RE: **Zone Map Amendment** – Change Zoning District from SS to PUD
Final Development Plan Modification to PUD – Chick-Fil-A
Application Number: 20230739

Chick-fil-A
501 East Kemper Road
Modification to a PUD and Zone Map Amendment
Application# 2023-0739
November 14, 2023

CHICK-FIL-A
501 E. KEMPER ROAD
PLAN REVIEW APP # 20230739
19020115
NOVEMBER 10, 2023

PLANNING COMMISSION
ENGINEERING REVIEW

SHEET NUMBER
C200

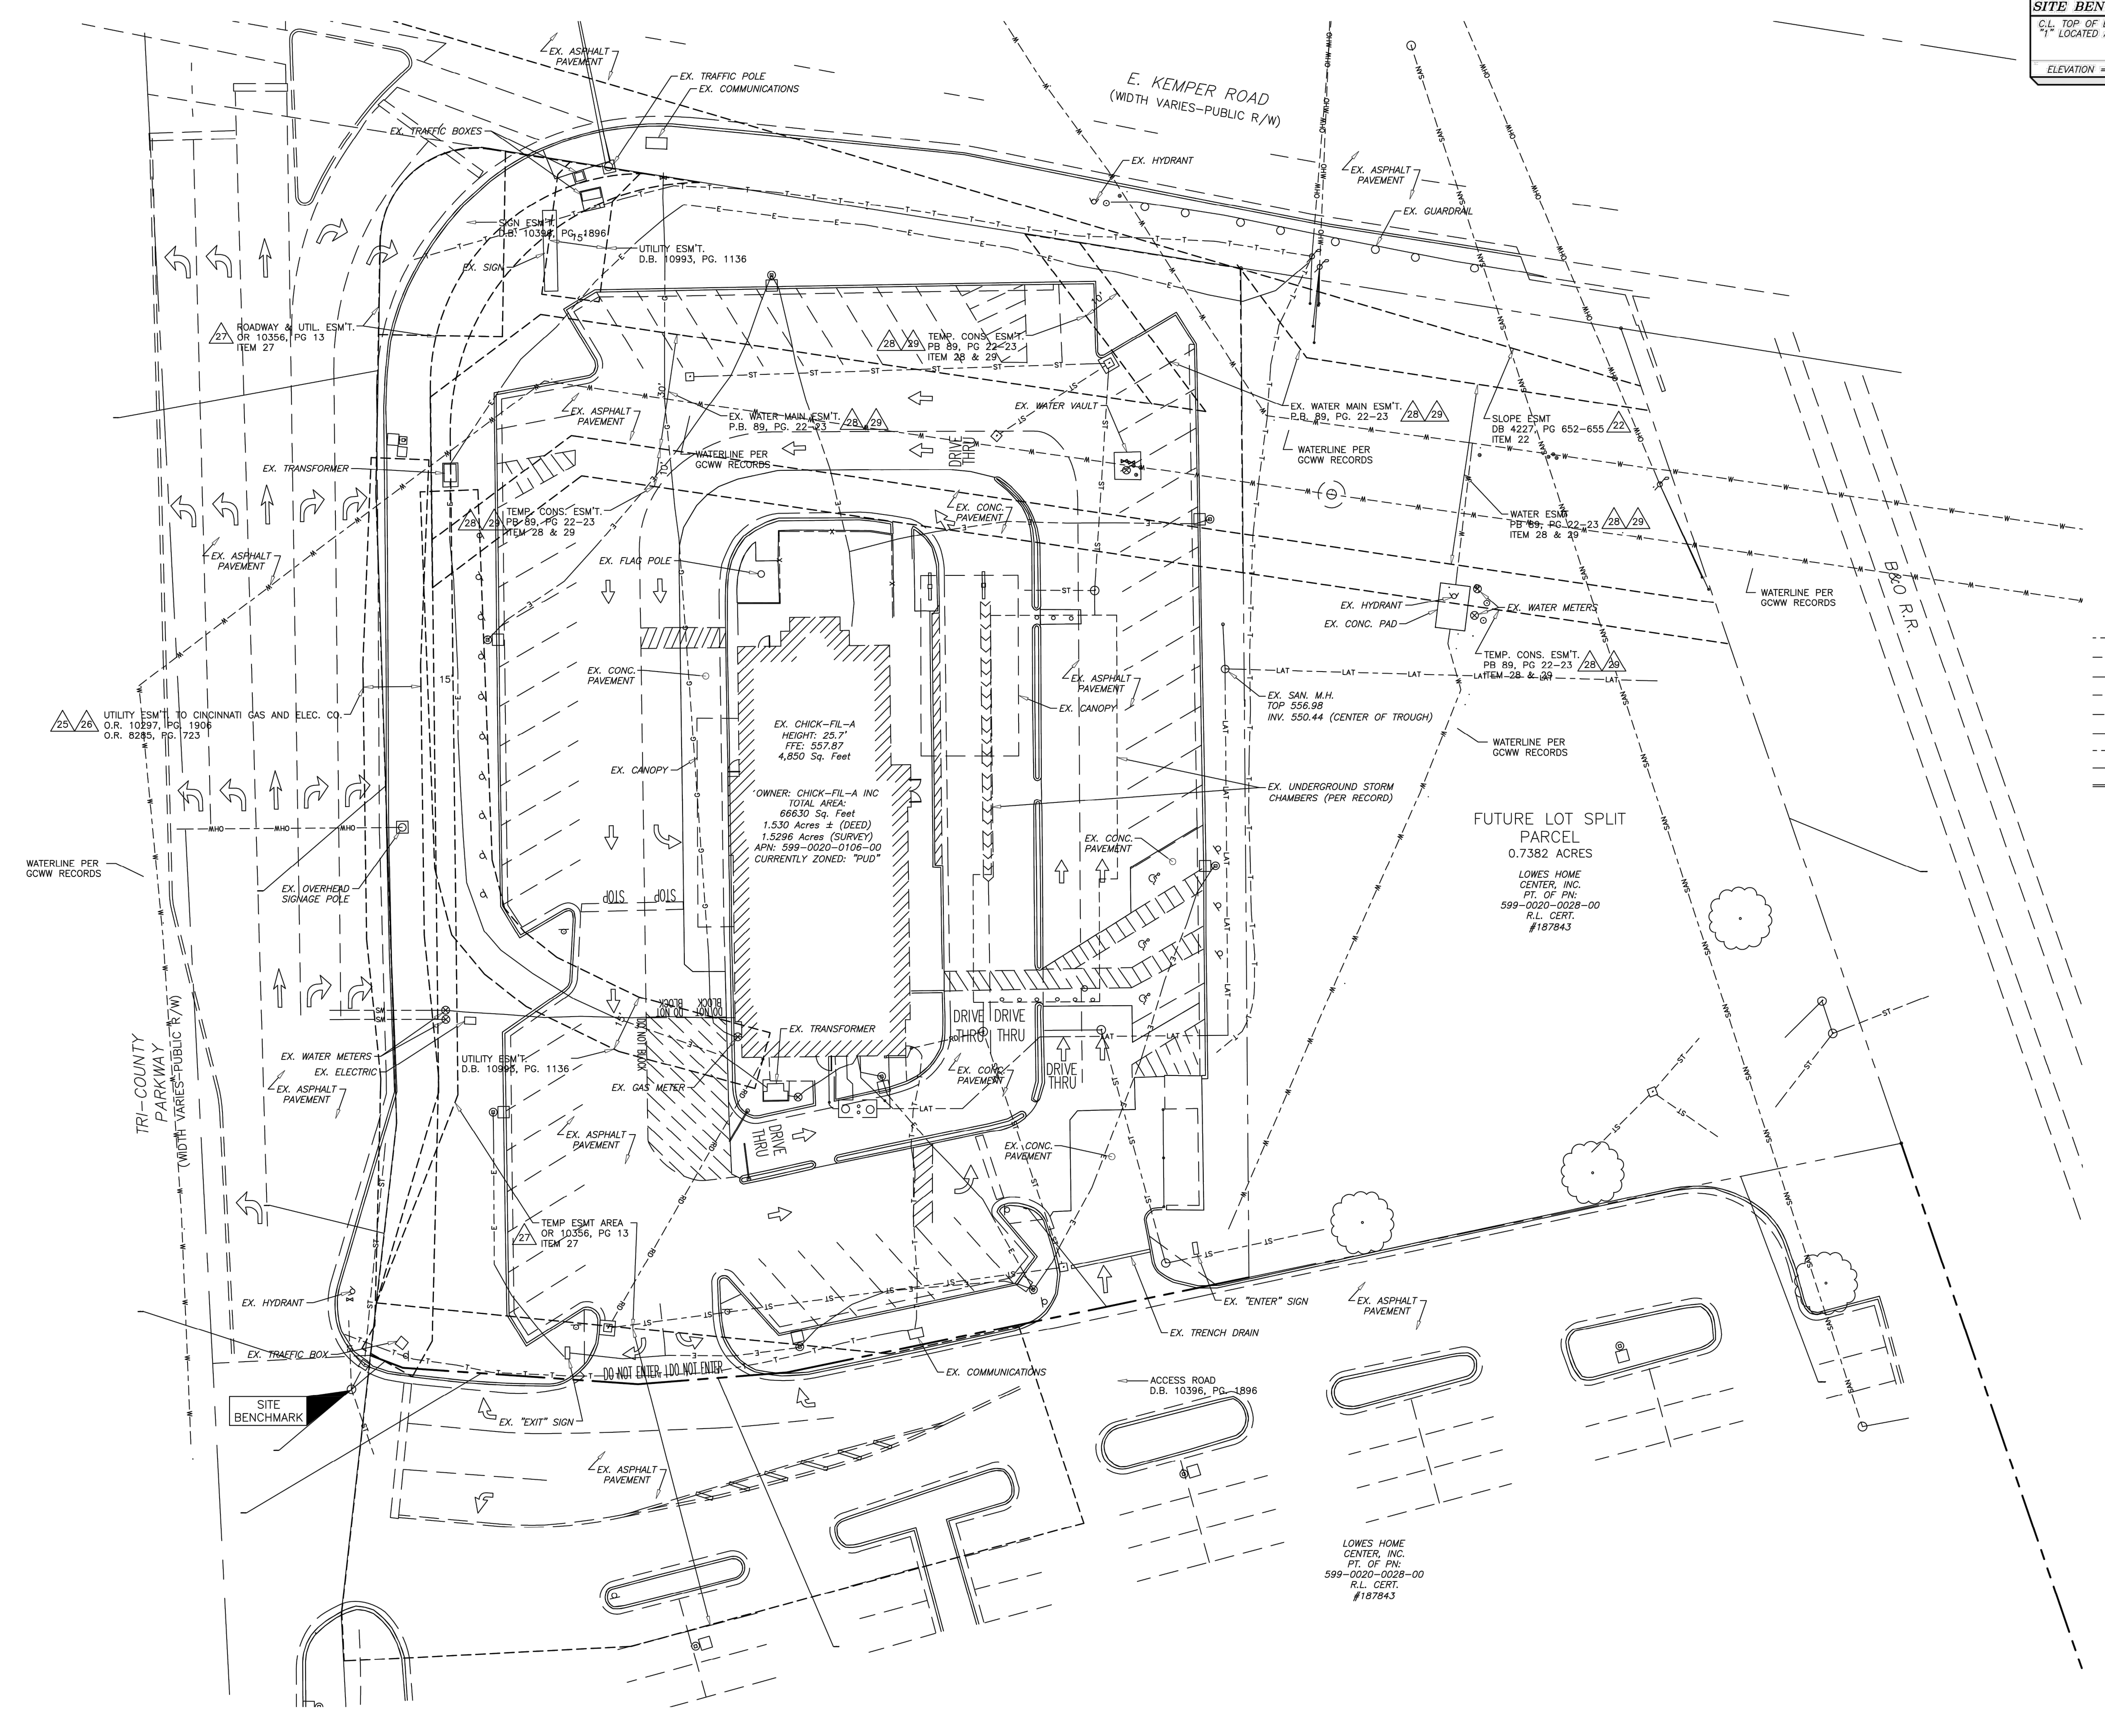
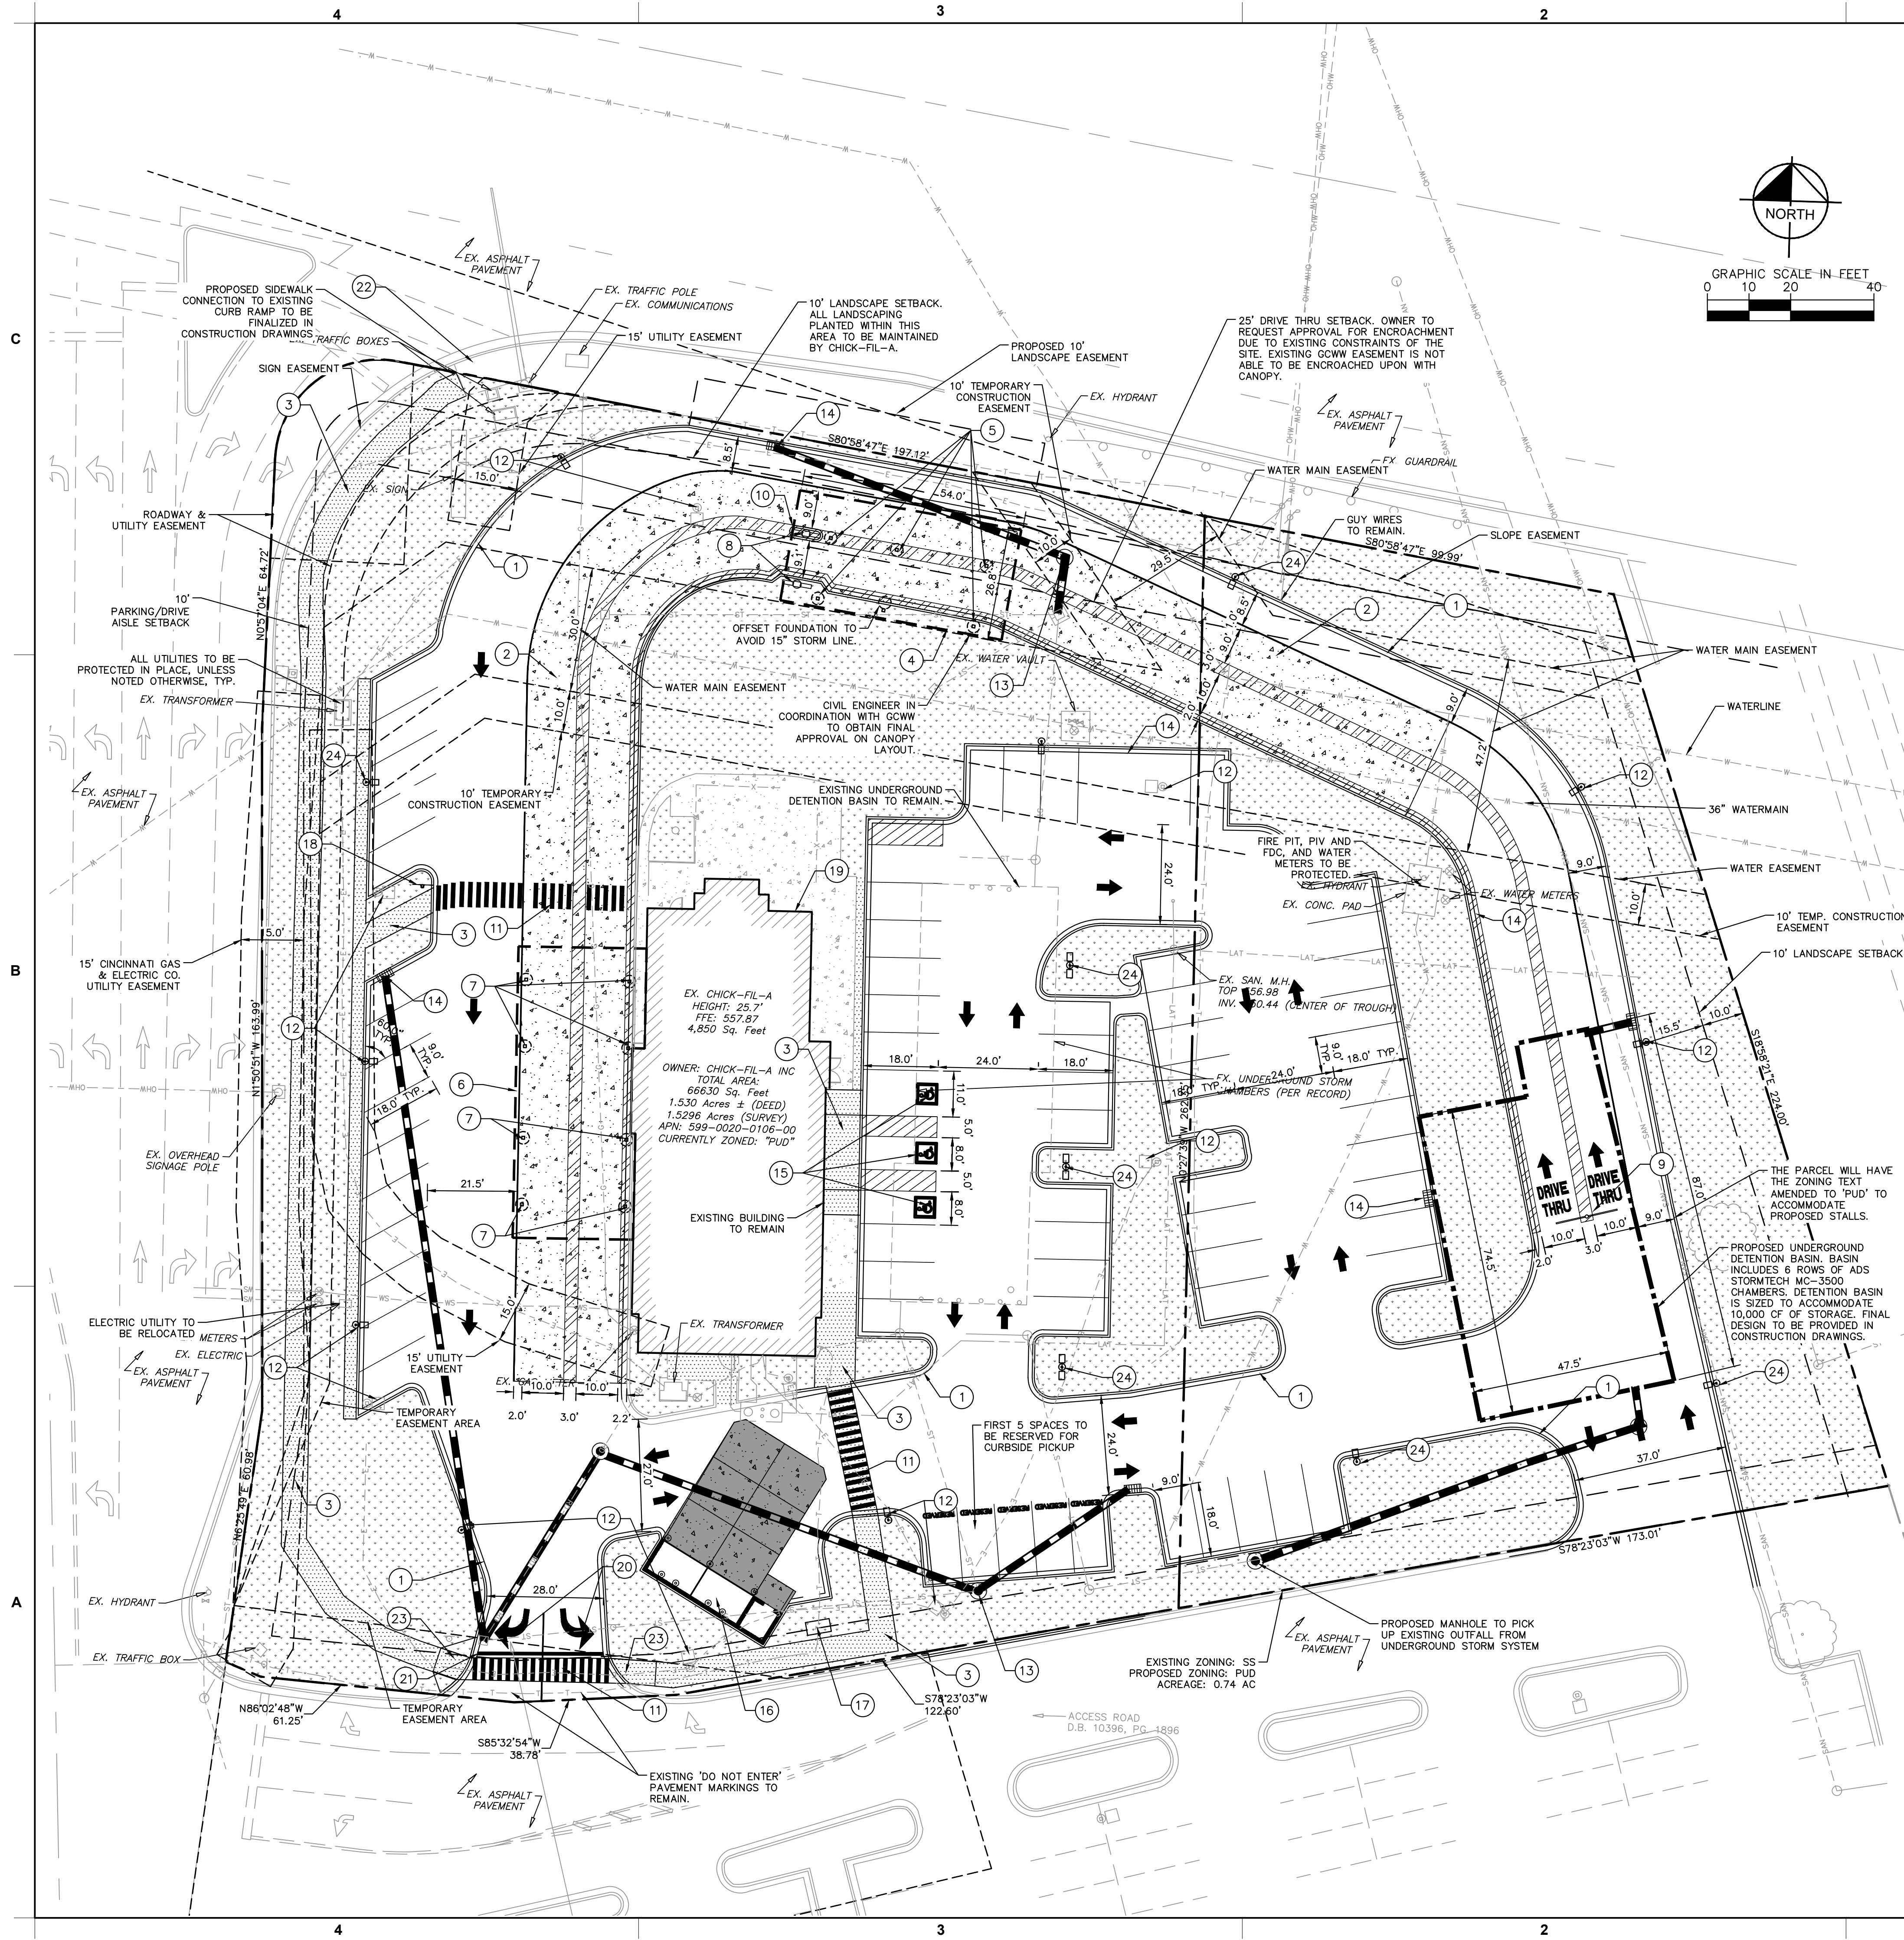
back from public or private/access drives 10 feet to the north (adjacent to East Kemper Road) or the south (adjacent to the private access drive). The applicant indicates in written correspondence that all the setbacks will be 10 feet, consistent with Section 153.404 (G) however, Sheet C-200 still shows setbacks below 10 feet and landscaping in the bypass lane.

- 4) The proposed drive thru stacking lanes are indicated to be 9 feet in width where 10 feet is required per Section 153.304 (B) (1). In written correspondence, the applicant indicates that the stacking aisles will be 10' wide, however Sheet C-200 shows them as 9' wide.

- 6) Section 153.302 (D) (5) requires the bypass access drive to be a minimum of 10 feet in width. Sheet C-200 indicates the bypass access is to be only 9' in width.

- 7) To provide a safe pedestrian connection across the drive aisle and two drive thru lanes on the west side of the store, a flashing Ped X sign needs to be provided at the crosswalk. The applicant has indicated such a sign on Sheet C-200.

- 6) The applicant provide the proposed setbacks for the drive thru stacking lanes and Planning Commission determine if the proposed setback is appropriate.
